HOPE CREEK GENERATING STATION
DOCKET NO. 50-354
NRC REVIEW OF STRUCTURAL/GEOTECHNICAL TOPICS

Attachment: Resolution of NRC Comments on
Structural/Geotechnical Topics

Response to NRC Audit

REACTOR BUILDING ELEV 145 N-S OBE RESPONSE DUE TO SIMPLIFIED 6S1A
(2% DAMPING)

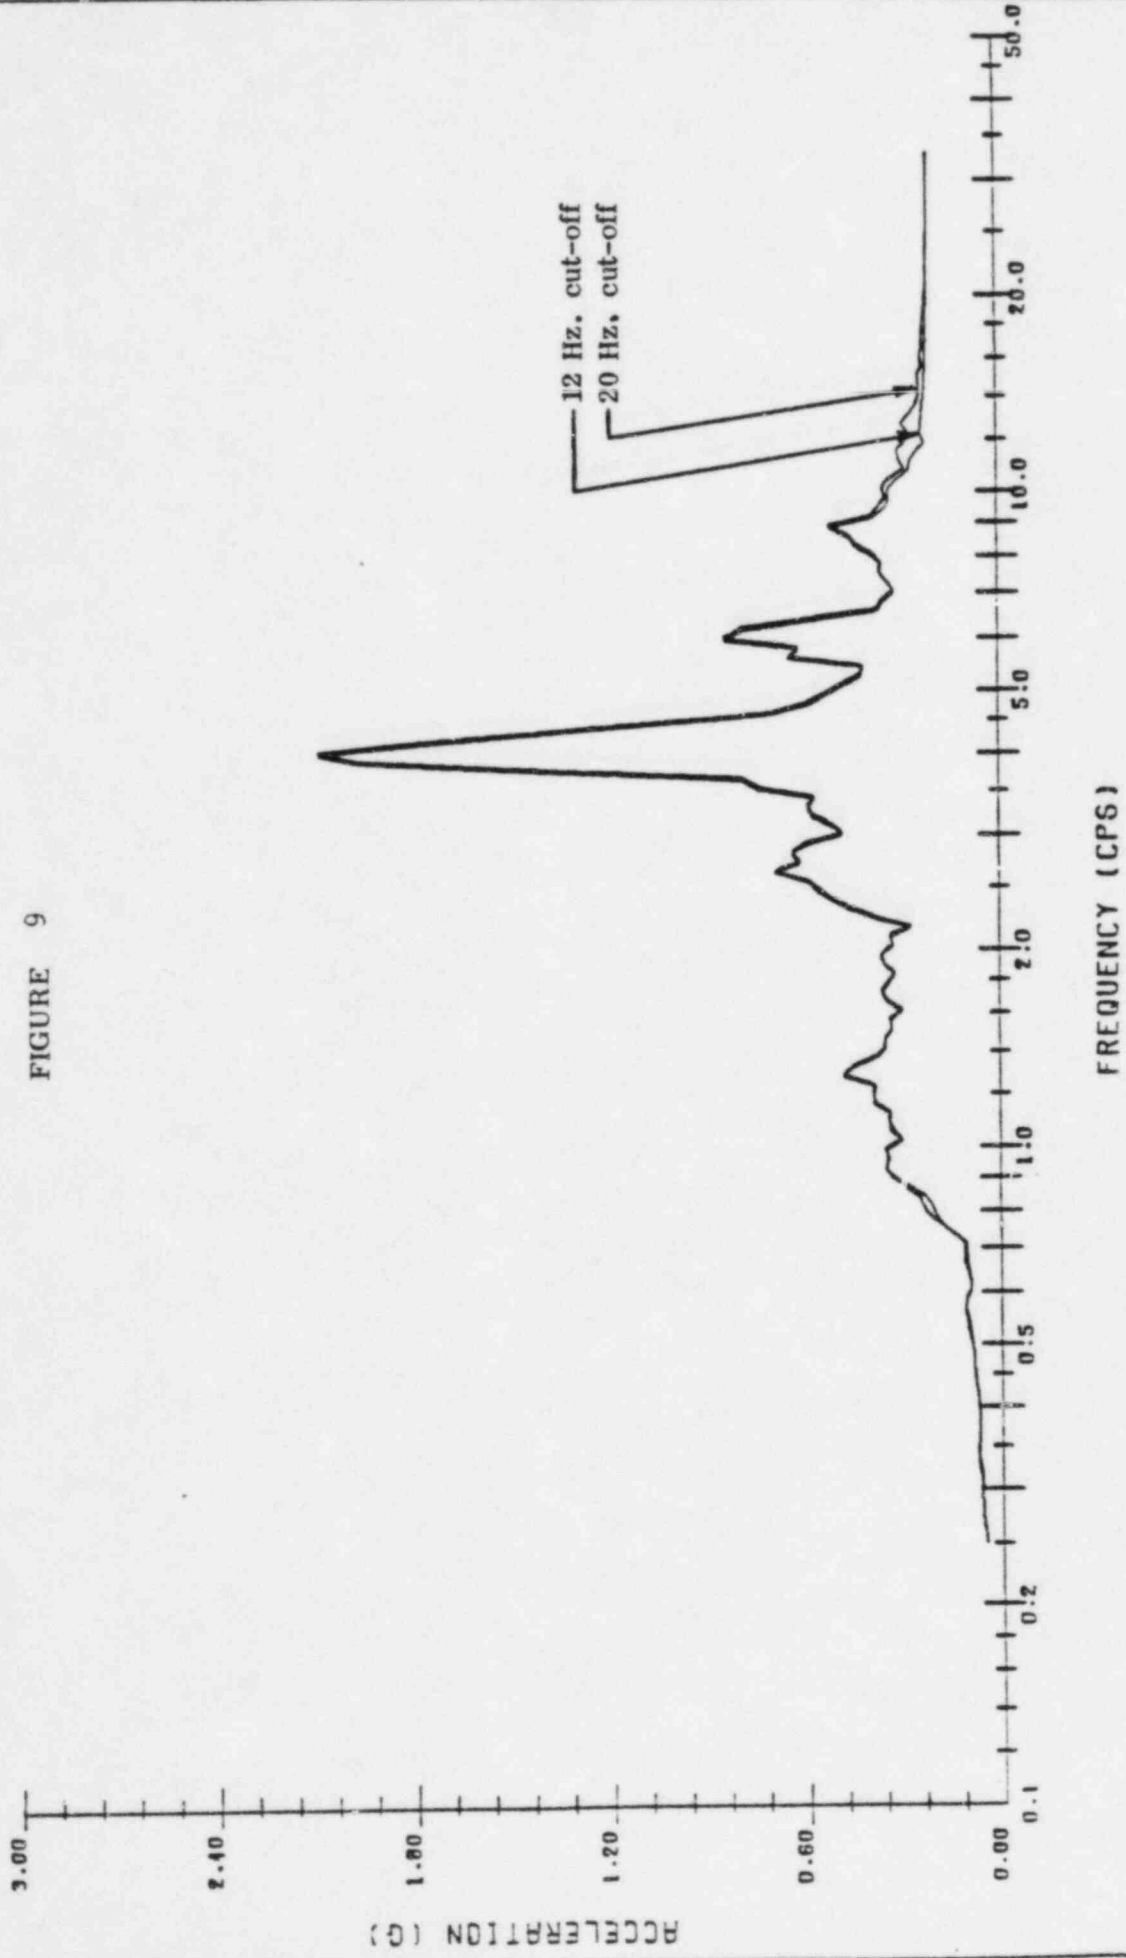
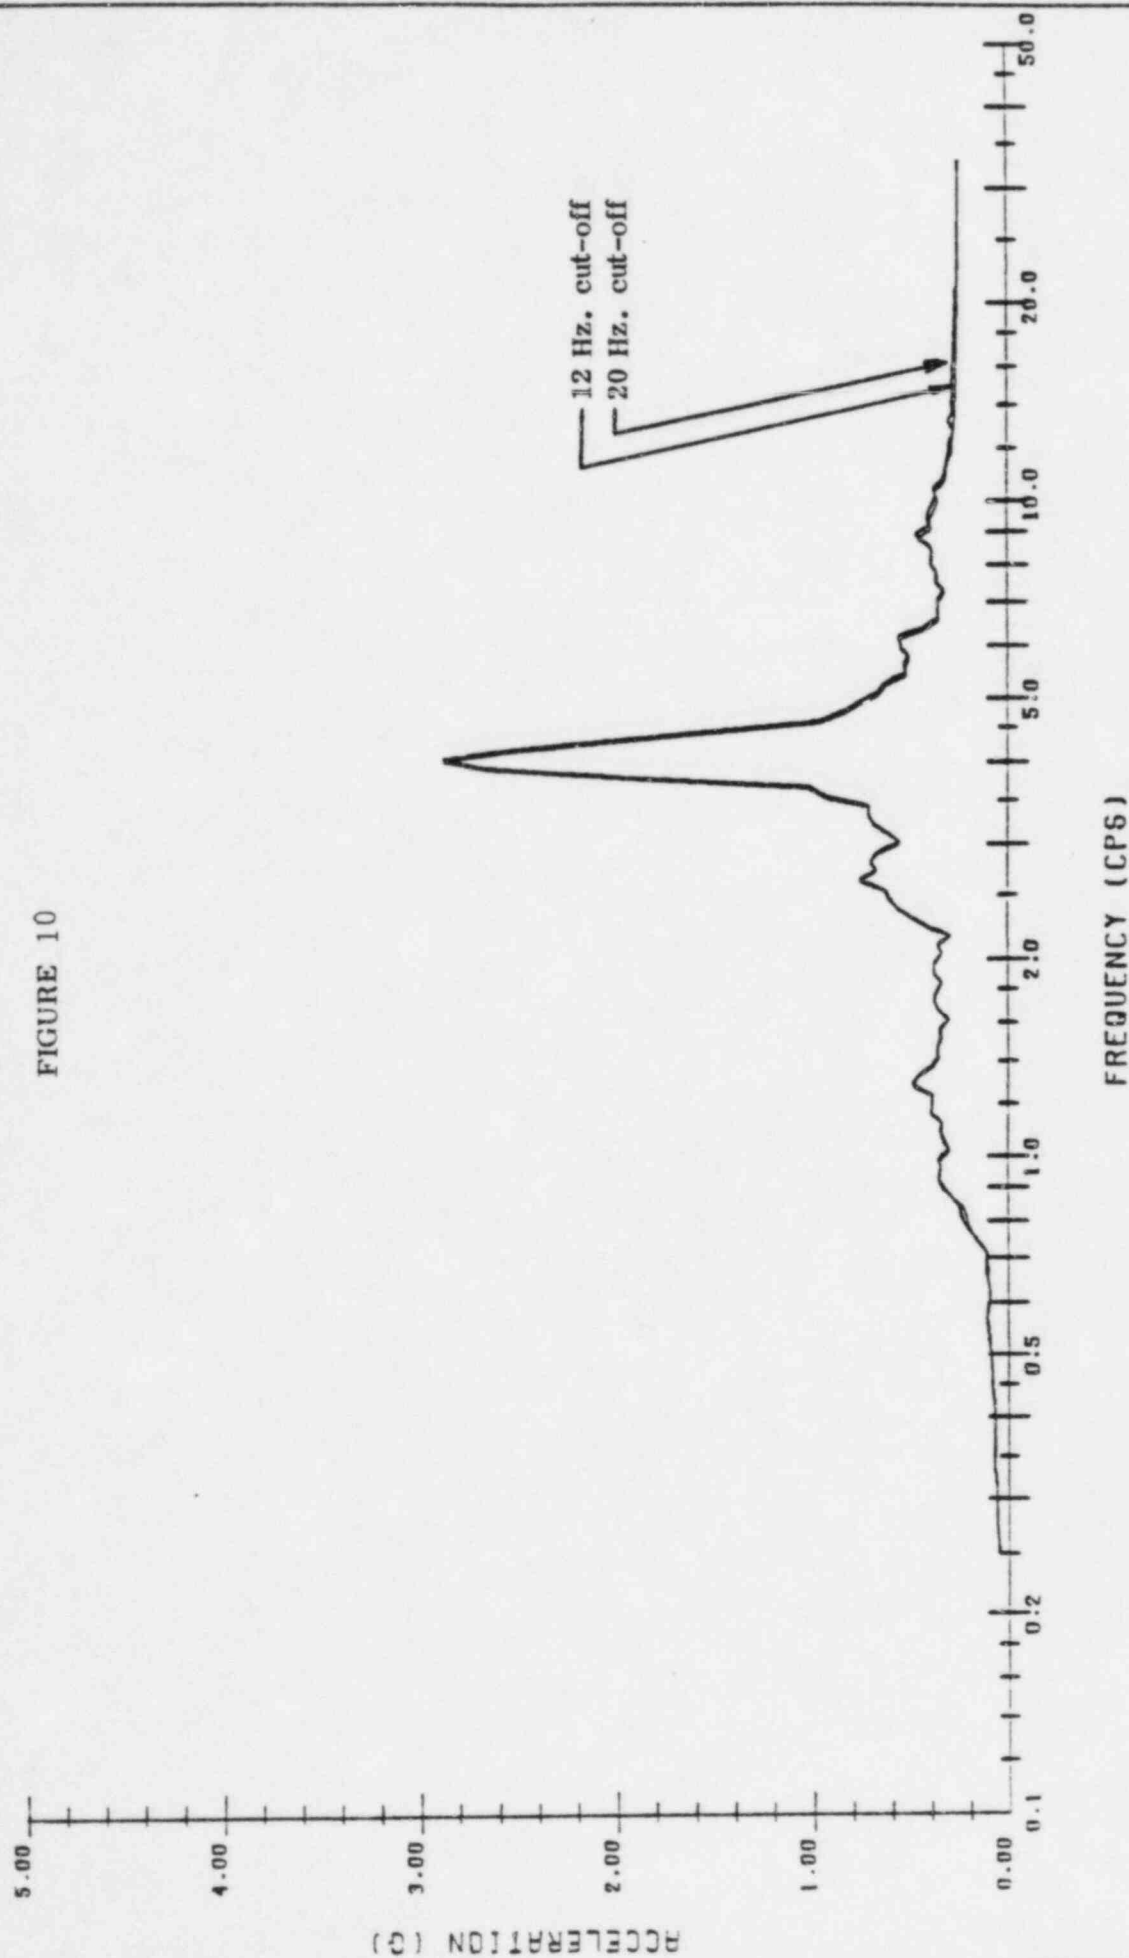
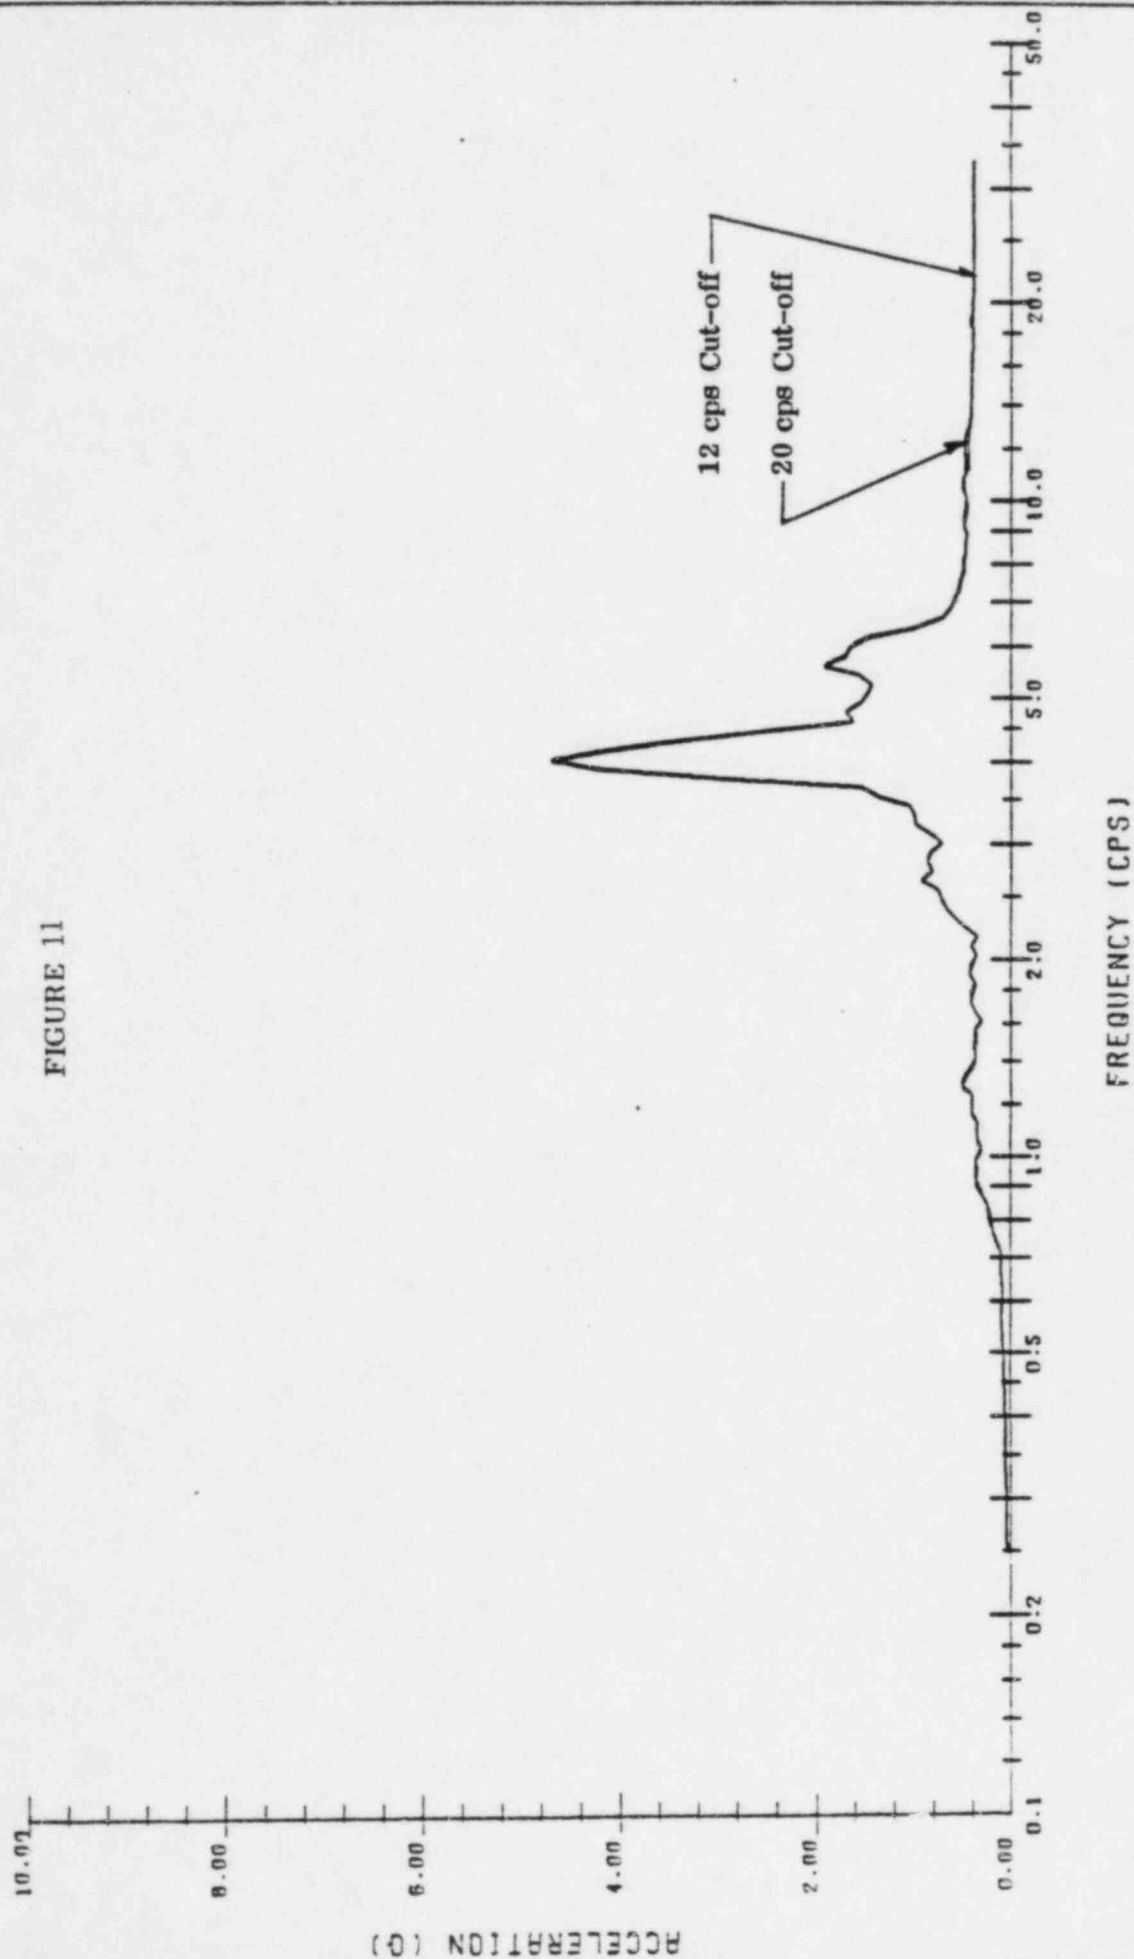
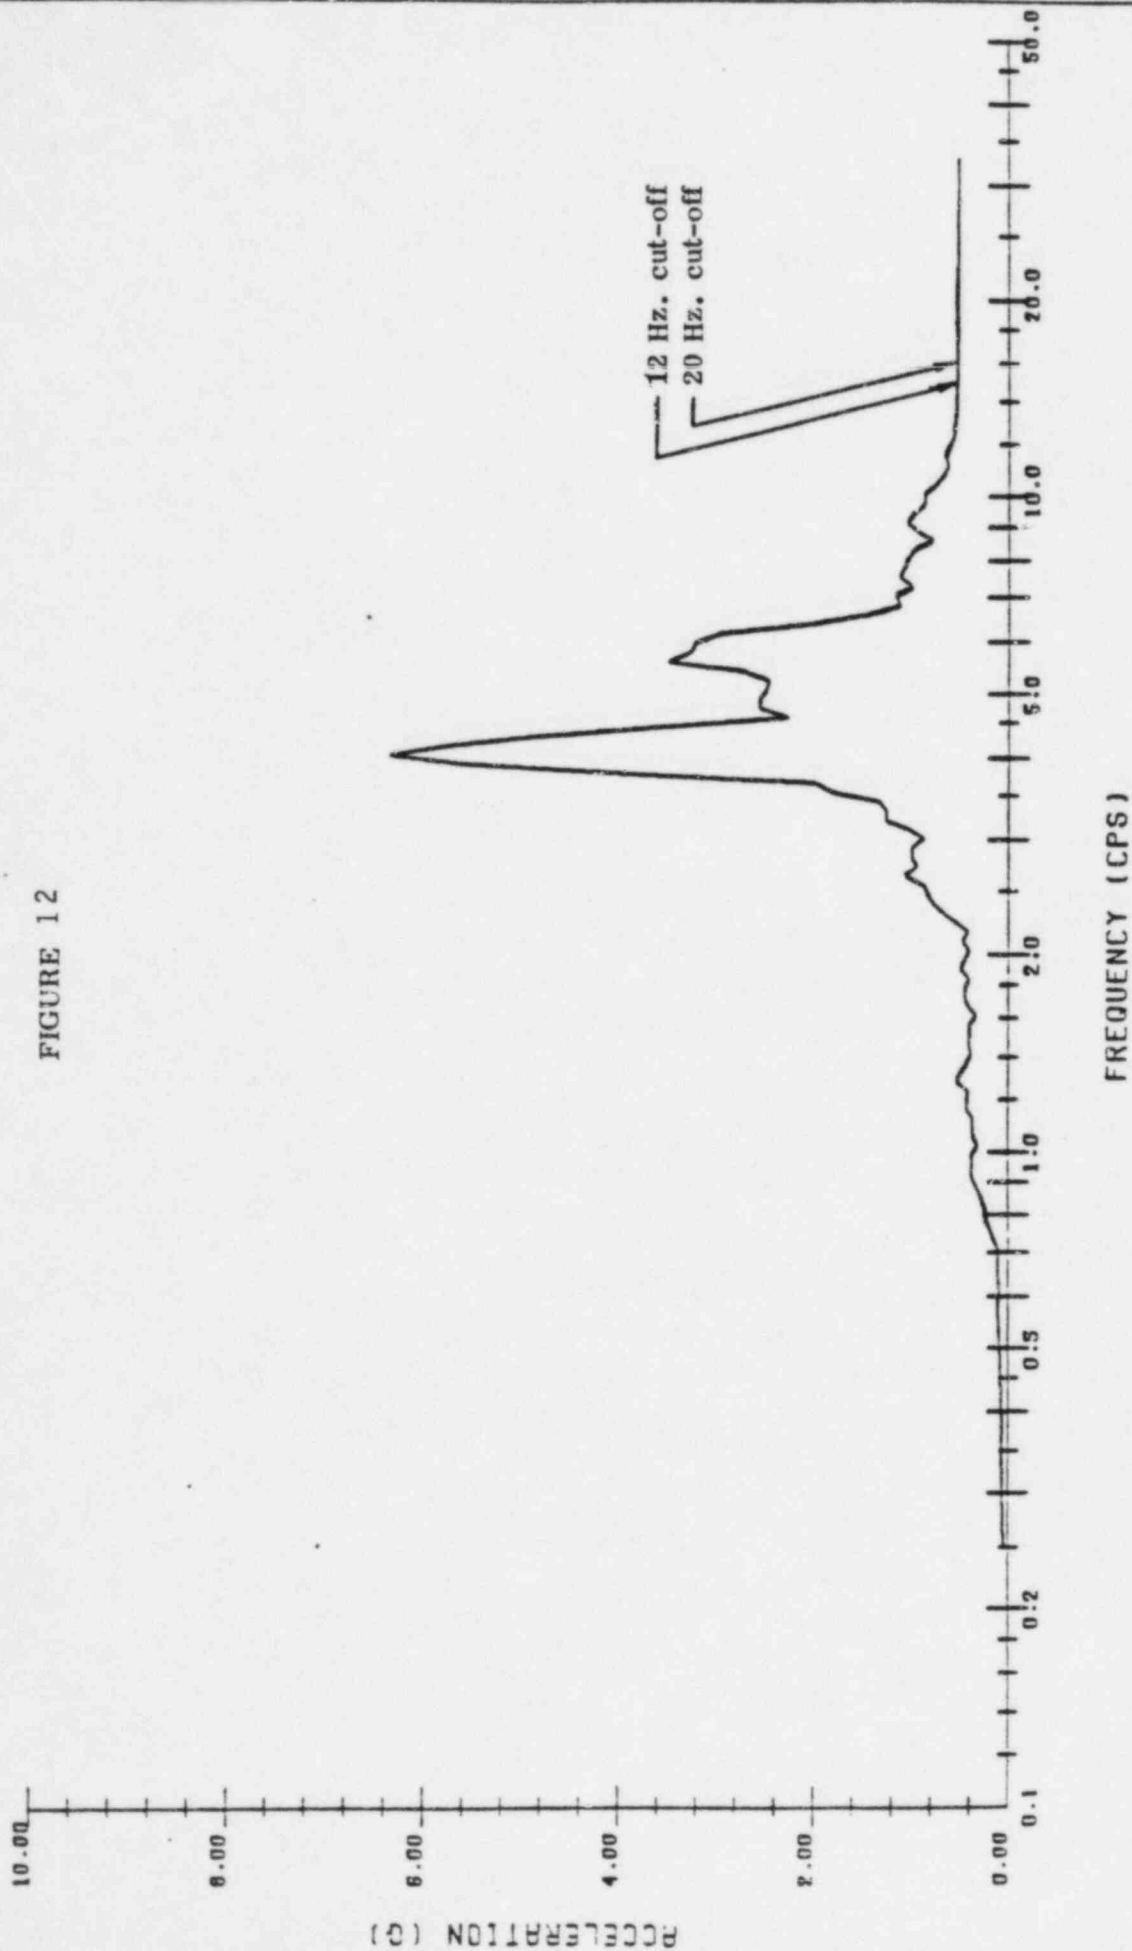
QUESTION: Justify the 12 Hz. cut-off frequency for SSI analysis.

Response spectra plots at various elevations of the Reactor Building are presented in Figures 9 through 12. As can be seen from these figures, the spectral accelerations in the low and mid frequency range are essentially identical for the two cut-off frequencies. In the frequency range above 12 Hz., there are minor differences at the lower elevations of the Reactor Building, but almost no variation in the upper elevations. For all elevations, the overall trend of the curves is identical, duplicating peak response values and shape of the spectral curves.

Intake Structure
Comparison of Peak Shear Strain Versus Depth,
Suggested Soil Properties

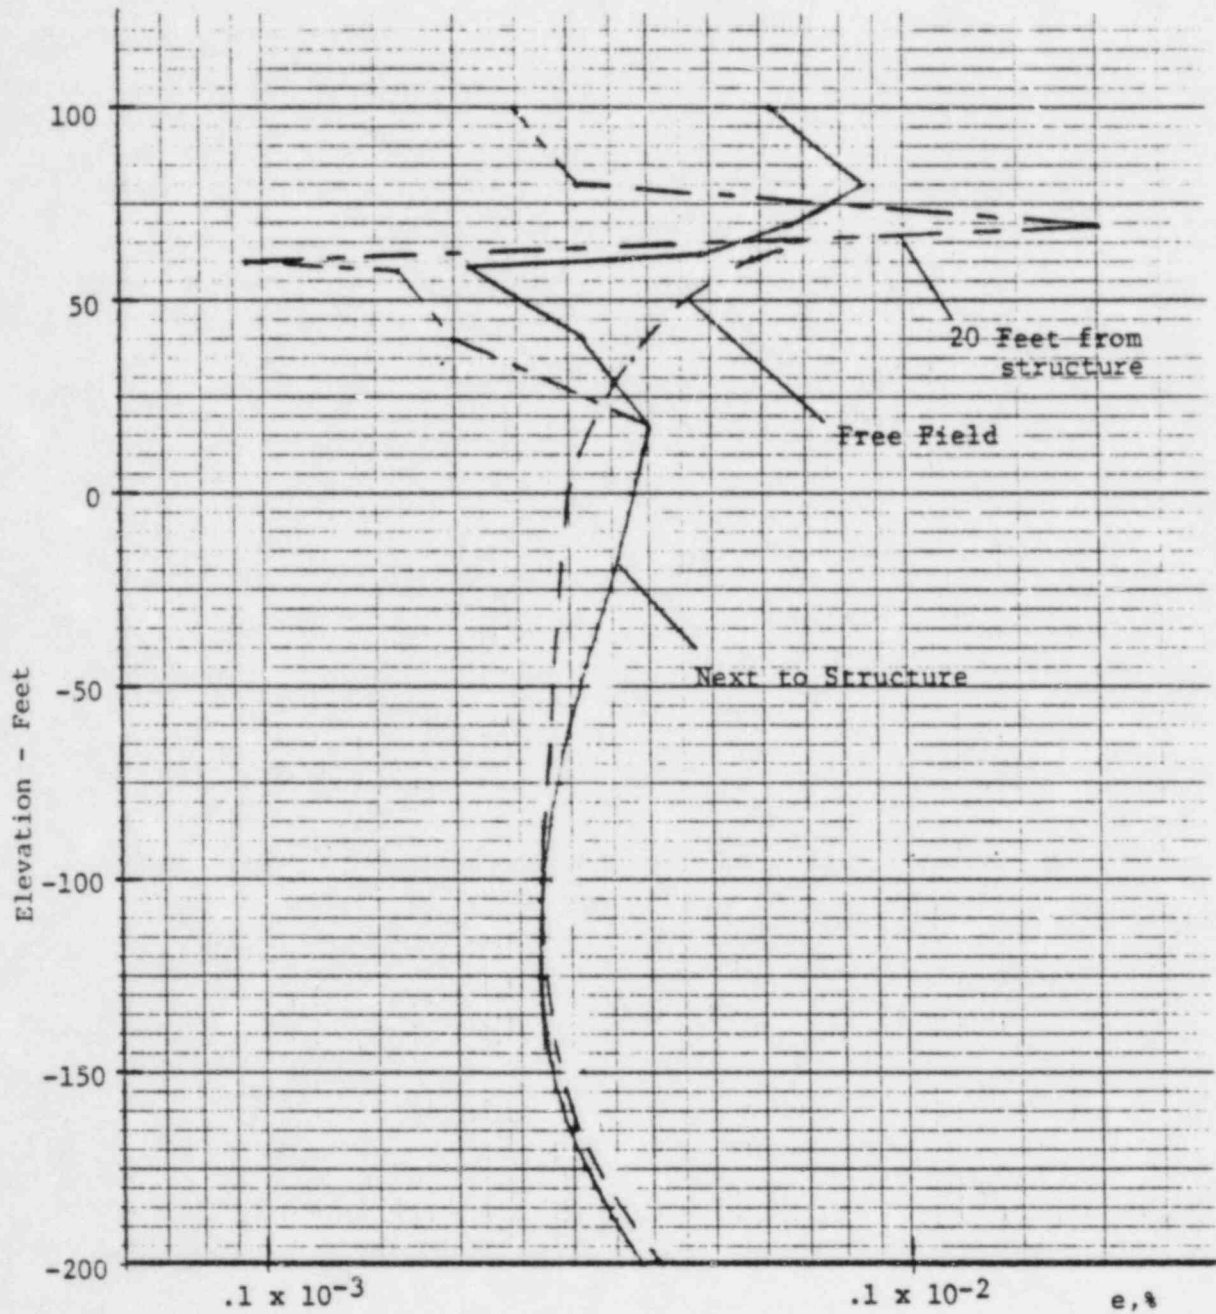
Question: Provide results of three soil depth models for intake structure.

Response: Since the intake structure is a considerably smaller structure than the Power Block structures, the depth of significant interaction for the intake structure is expected to be equal or less. To substantiate this, plots of peak shear strain with depth were developed for the following conditions and are shown in page 1 of the attachment:
